**TOWN OF PORTOLA VALLEY  
ARCHITECTURAL AND SITE CONTROL COMMISSION (ASCC)  
Monday, January 13, 2014  
Special Field Meetings (time and place as listed herein)  
7:30 PM – Regular ASCC Meeting  
Historic Schoolhouse  
765 Portola Road, Portola Valley, CA 94028**

**TO:** ASCC  
**FROM:** Tom Vlastic, Town Planner  
**DATE:** January 9, 2014  
**RE:** Agenda for January 13, 2014 ASCC Meeting

***ARCHITECTURAL REVIEW & X9H- 665 FOR  
NEW RESIDENTIAL DEVELOPMENT  
7 VERONICA PLACE, WAISSAR***

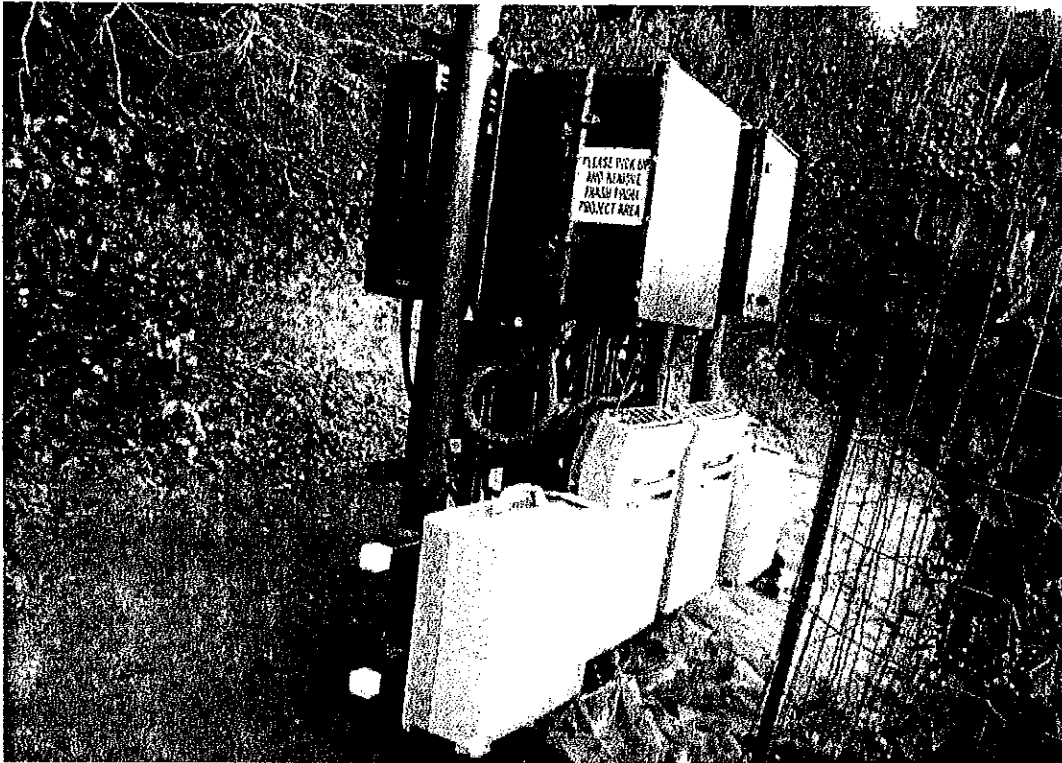
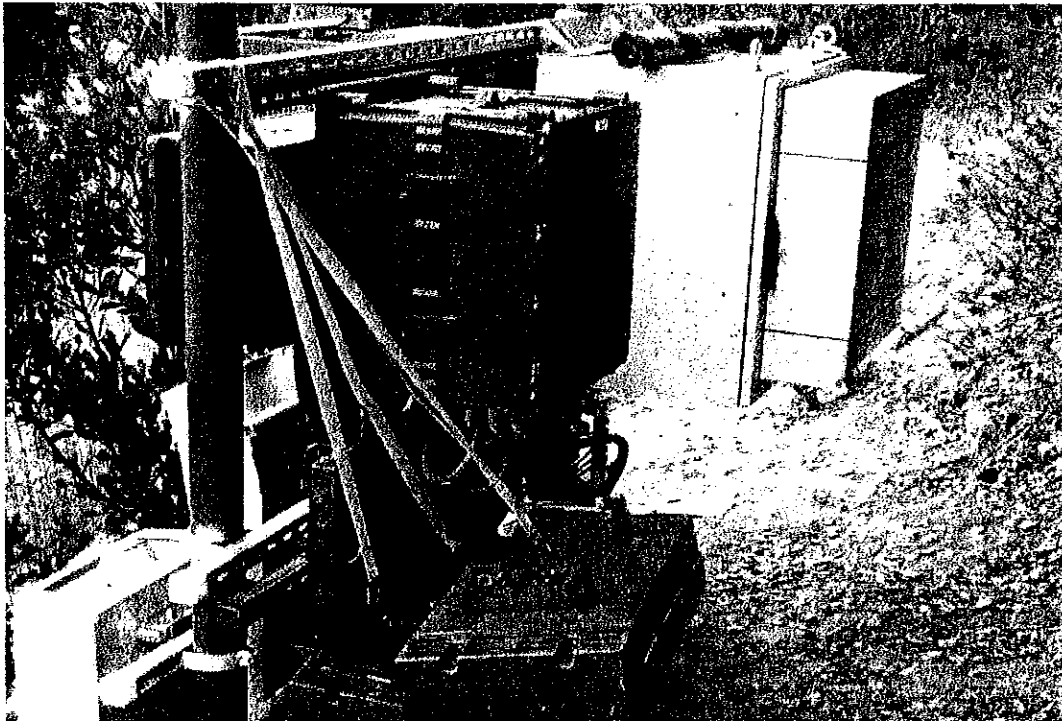
The front view shows four new RRU's (two each of two different models). These four RRUs take the place of the two old RRUs that were mounted on the front of the H-frame.

The back view also shows old RRUs that are temporarily suspended from the H-frame. The front view also shows that the RBS 3818 has not yet been removed. Both the old RRUs and the old RBS 3818 would have been removed once the installation of the new equipment had been completed, and the technicians had verified that the new equipment was operating properly.

**Sheet:** L2.1  
**SWAC**

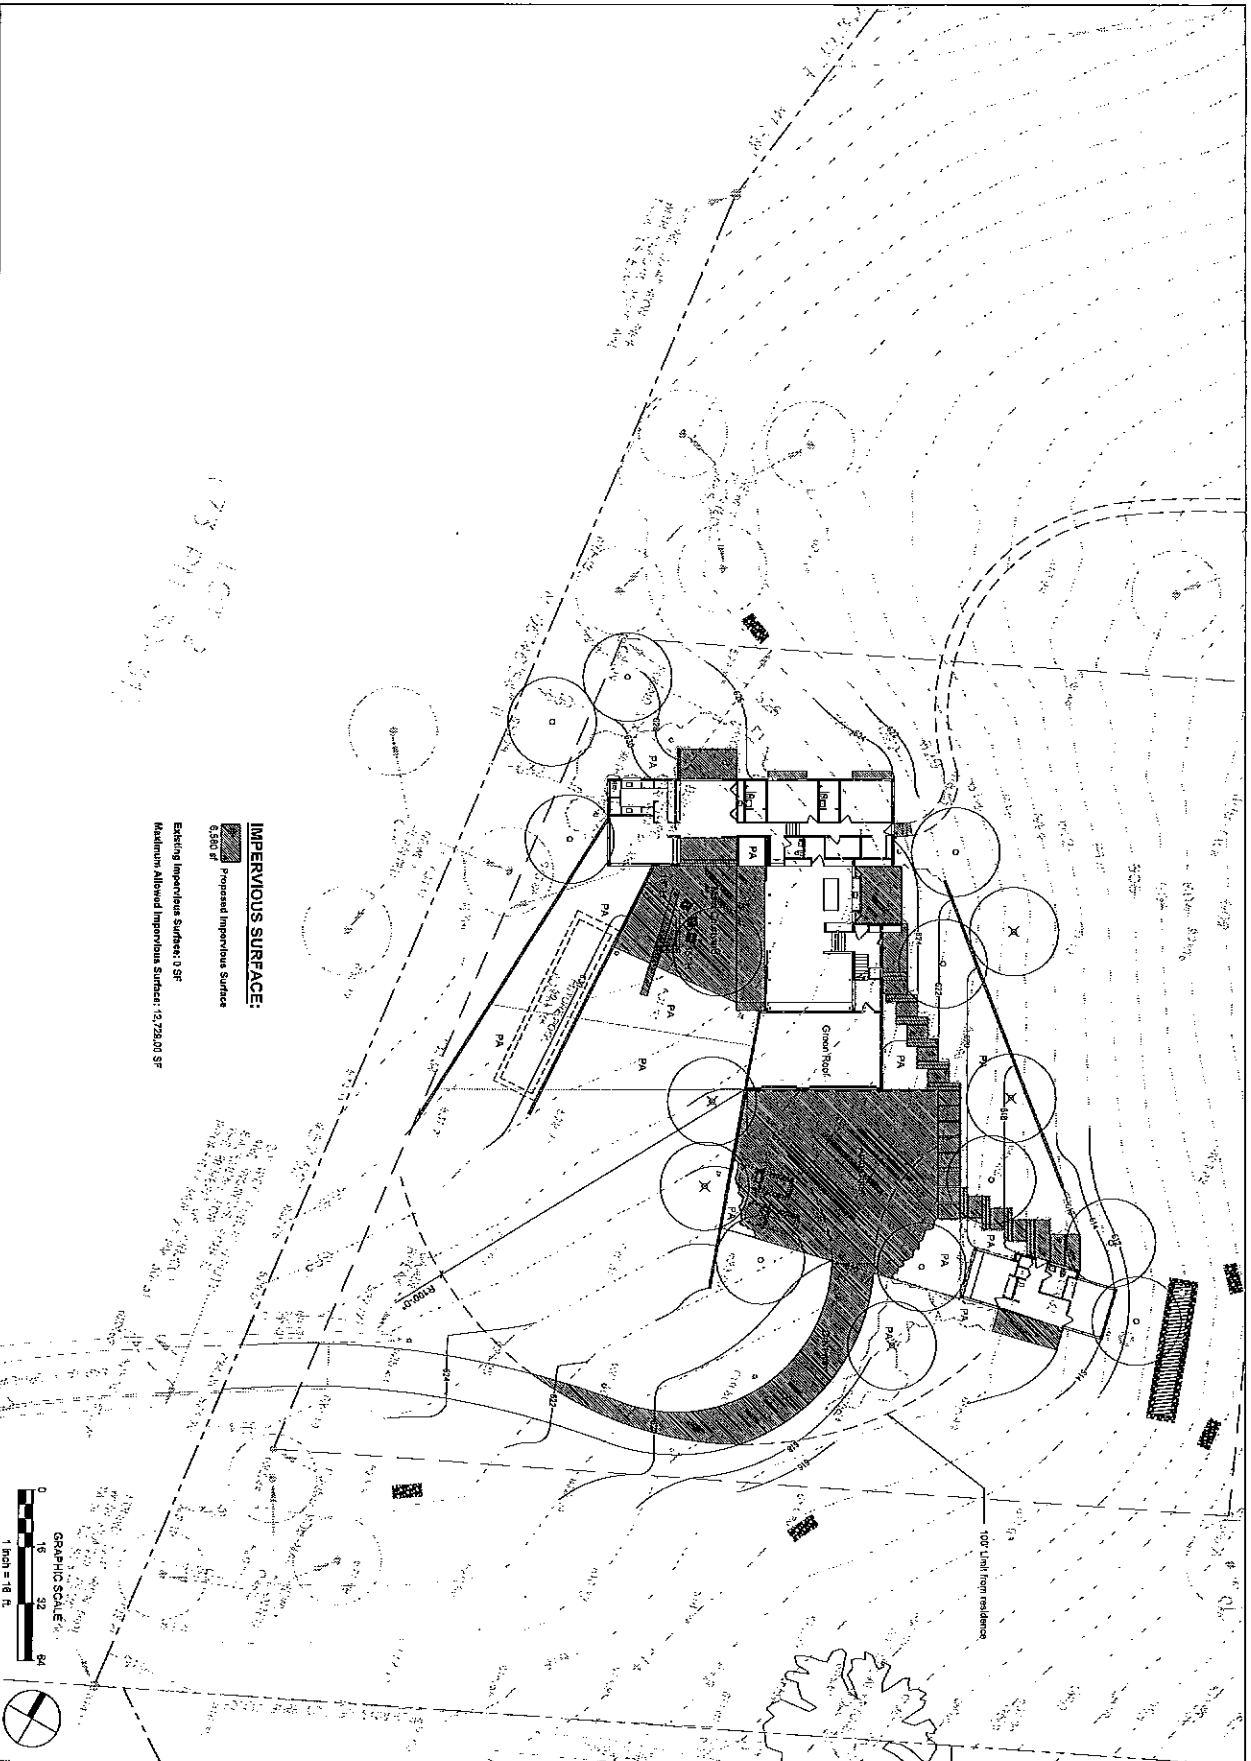
Landscape lighting is shown on Sheet L2.1 and includes 2-inch diameter "mini-bollard" style pathlights to be located along the steps between the house and guest house (cut sheets attached). The fixture conforms to Town lighting guidelines, will have a bronze finish, diffused glass, a capped top, and accommodates an 8-watt LED bulb. Nine of these pathlights are proposed along the steps leading from the house down to the guest house, and consideration should be given to reducing this number by one or two lights.

The adjustable 8-watt LED Staff Star lights with black finish (fixture cut sheet is attached) proposed for the fire pit patio meet town guidelines and are appropriate for the location.

*RESPONSE: The tree lights have been eliminated and (2) new path lights, "B-K Lighting Staff Star" have been added to the interior courtyard, see sheet L2.1 and the (2) new copies of the revised lighting specs. In order to provide adequate path light between the Main House and Guest House only (4) lights have been removed from this courtyard. We feel (9) lights, as shown in the drawings, shall provide adequate path light for the primary entry path and we would not recommend removing any additional fixtures.*

**A3.02**

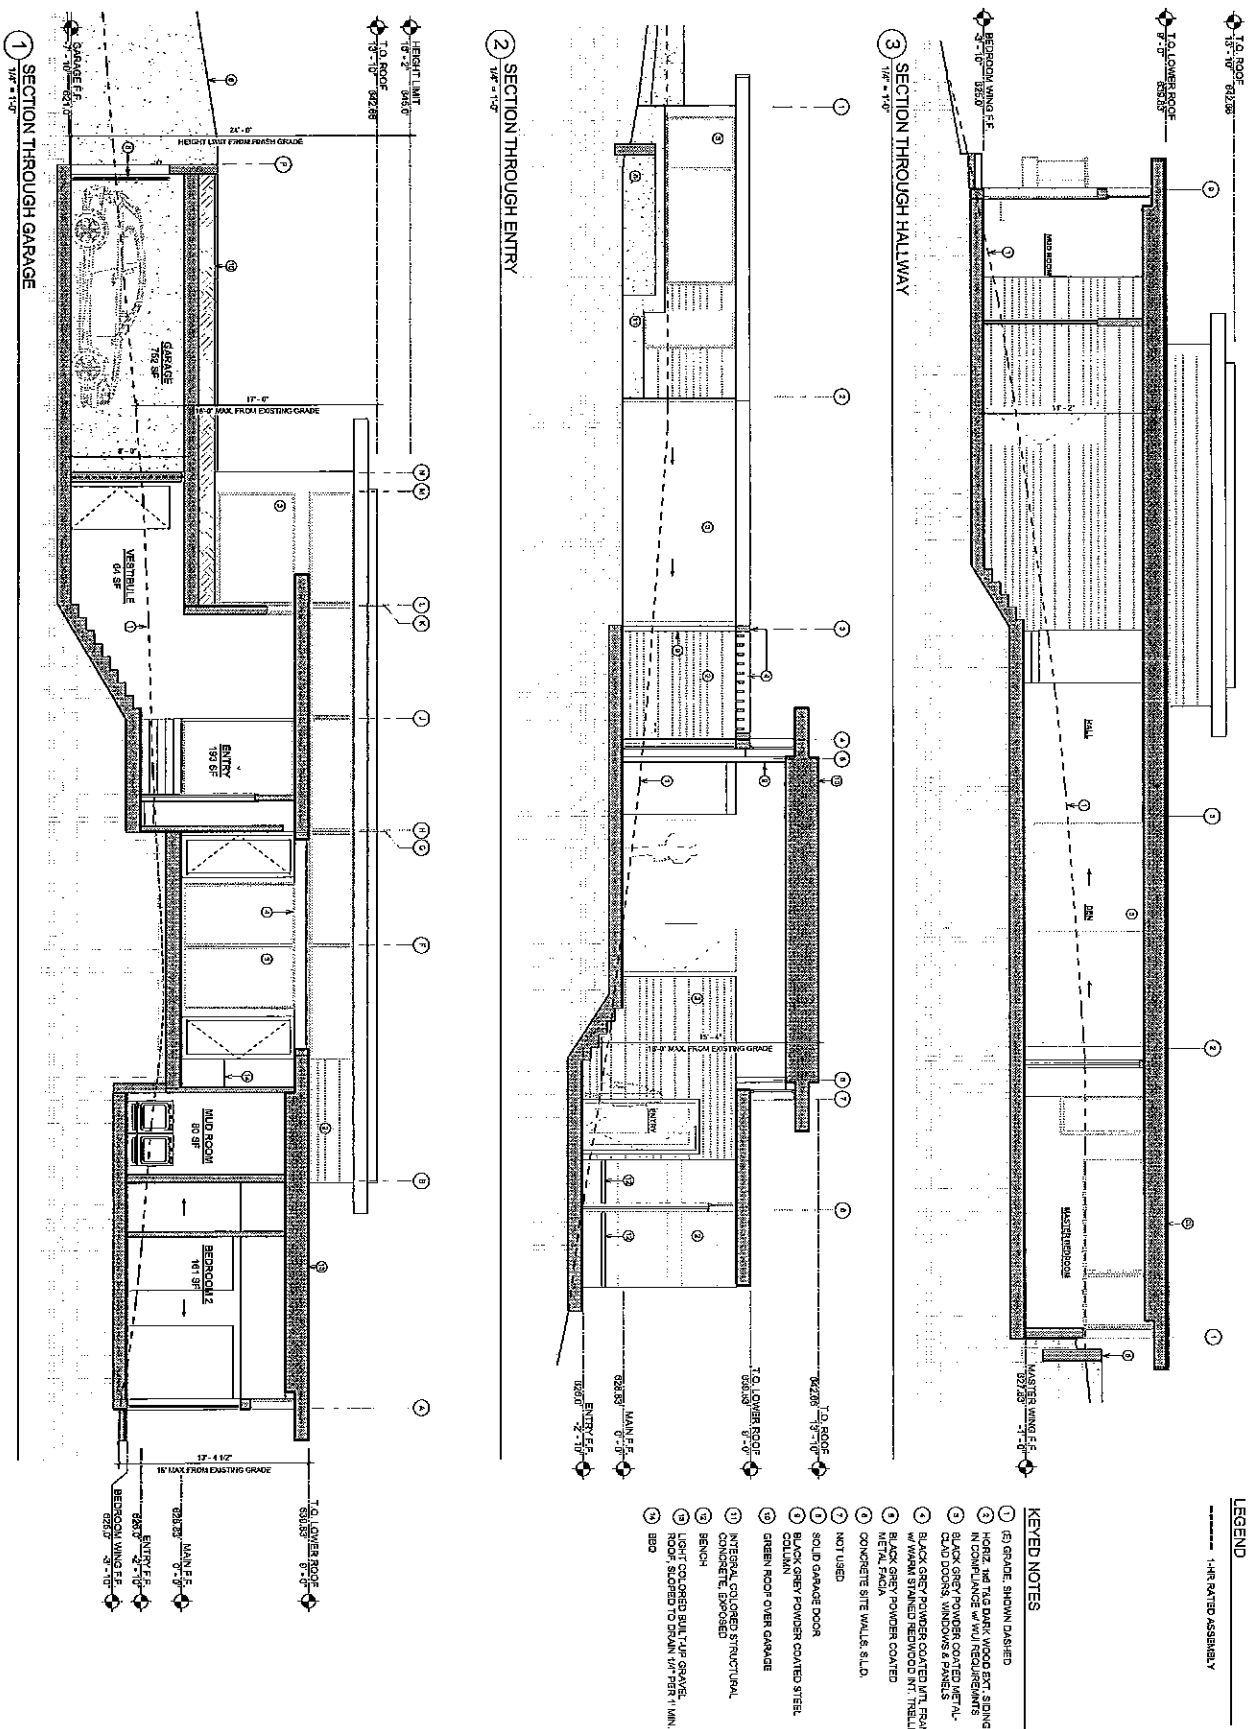
The PUD calls for single story development which limits the building height to 18 feet and the maximum building height to 24 feet. These limits can be exceeded if approved by the ASCC, in which case, the maximum heights of 28 and 34 feet would be permitted by ordinance. The proposed maximum height of the residence is 21-feet 8-inches and complies with the PUD. However, the proposed building height on Sheet A3.01 is approximately 19 feet and will need to be approved by the ASCC, although given the overall design approach this is viewed as a minor issue. The guest house fully conforms to the single-story height requirements as shown on Sheet A3.02 and has a maximum height of just over 14 feet.
